Critique of Amherst Island Wind Project

Noise Assessment Report

Prepared for Windlectric Inc.

Date: March 4, 2013

Figure 4-Predicted community response to Amherst Wind Project

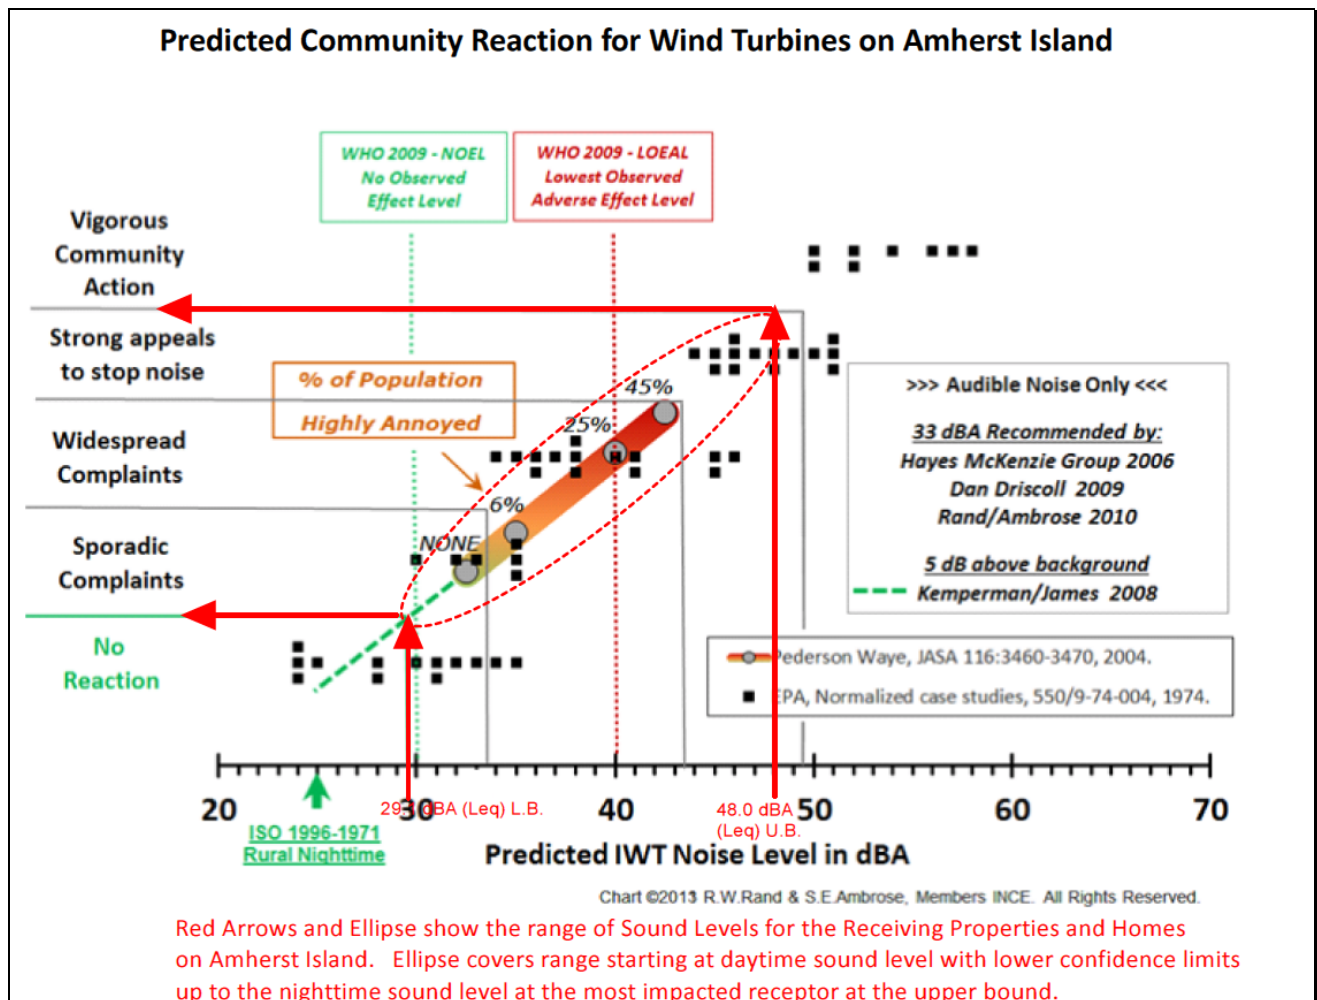
To demonstrate that the Amherst Wind Project is not compatible with the host community Exhibit I has been prepared to show the impact of considering the higher sound emissions and immissions that occur on typical nights. The table is based on the information from the Amherst Wind Project Noise Assessment Report, Table C.1 Noise Impact Summary. To that information two additional columns have been added to the right by this reviewer to represent the operation of the Amherst Wind Project during the day with the ISO 3 dB upper bound for day to day variability in sound and 5 dB for operation at night. As explained earlier, nighttime operation can cause increase of 5 to about 15 dBA over daytime operation. For this example, a 5 dBA increase in the Leq (mean sound level) has been assumed. The last column represents that "nighttime" condition with 3 dB added to the mean Leq to identify the upper bound for sound levels at night. The table has been color coded to show which properties and home will exceed the MOE LIMIT of 40 dBA during nighttime operation. Yellow highlights show receptors that will exceed the 40 dBA limit when the Hatch model representing daytime operation plus 3 dB for variability in weather conditions occurring over multiple days, weeks, or months is considered. Pink highlights show the additional receptors that may exceed 40 dBA during operation at night when higher wind shear and turbulence is present than was present for the IEC 61400-11 measurements of sound power levels. This includes the 3 dB adjustment for variability in weather and sound propagation required for ISO 9613-2.

Using the information provide in this table it is possible to project the range of community responses to the proposed project. Figure 5 shows a chart from a pending paper by Steve Ambrose and Rob Rand, two acousticians from Maine who have done considerable work on wind turbines in the U.S.. This chart blends the Pedersen annoyance information with other community annoyance predictors. It is based on the L_{eq} and not the L_{dn} or L_{den} . This chart is also marked with red arrows showing the benchmark sound levels and has a red ellipse to show the range of responses to sound for the range of sounds shown in the Exhibit I: Table of Non-Participating Project Noise Receptors (436 receptors)" which is based on Hatch NAR, Appendix C, Table C.1

The ellipse shows that the range of sound levels for the day and night conditions at the most impacted receptor range from "sporadic complaints" at the quietest conditions (daytime L_{eq} under 30 dBA) to "Strong Appeals to Stop the Noise" for the typical nighttime L_{eq} of 48 dBA, just under "Vigorous Community Action" for the upper bound conditions at night.
